Entergy Operations, Inc.
1448 S.R. 333
Russellville, AR 72802
Tel 479-858-4619

1CAN100501

SUBJECT: Response to Request for Additional Information on Generic Letter 2004-01,
Requirements for Steam Generator Tube Inspections
Plant Name Arkansas Nuclear One, Unit 1
Docket No. 50-313
License No. DPR-51

**Response to NRC Requests for Additional Information for ANO-1
GL 2004-001, Requirements for Steam Generator Tube Inspections**

FIGURE 1 - BOBBIN NOISE AMPLITUDE

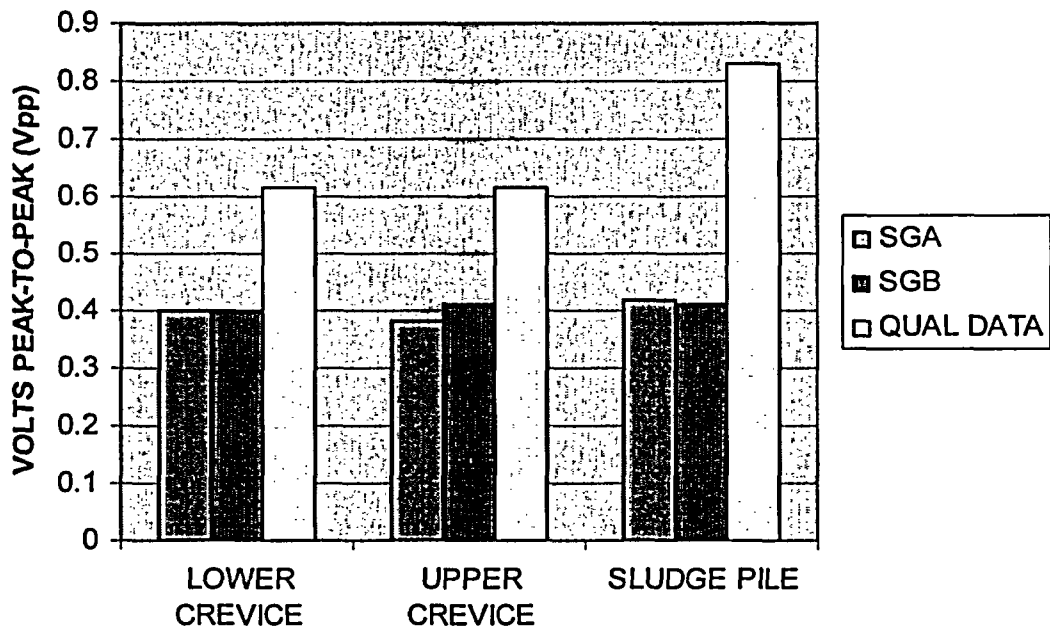
Please provide the technical basis demonstrating that the bobbin coil is capable of reliably detecting the potential forms of degradation (e.g., intergranular attack (IGA), stress corrosion cracking (SCC)) in this area, considering that other plants with similar design steam generators have stated tubes in the kidney region require the use of rotating coil for better detection of IGA due to sludge build up in the upper portion of the lower tubesheet crevice.

Noise in the LTS was compared to the noise for the qualification data set and to the noise in the UTS. Volts peak-to-peak (Vpp) and Volts Vertical Max (Vmx) measurements were taken for each tube in the qualification data set and for each tube chosen across the upper and LTS face. Figures 1 and 2 below provide a comparison of the values for the qualification data set, and for tubes in the UTS and LTS. When comparing the noise values between the UTS and LTS, the LTS maximum noise values were higher than the comparable UTS value but were still well below the maximum value from the qualification data set value. Comparison of the signal characteristics between the upper and LTS shows little difference in amplitude. In most instances noise remained in the horizontal plane for both tubesheets with little or no vertical component. The vertical voltage readings for both tubesheets in both steam generators is less than the vertical voltage measurements taken in the EPRI qualification data and will not degrade the POD. Based on the results of the bobbin noise data from 1R17 it is believed that the difference in noise between the UTS and LTS would not degrade the POD of qualification 96009.1.
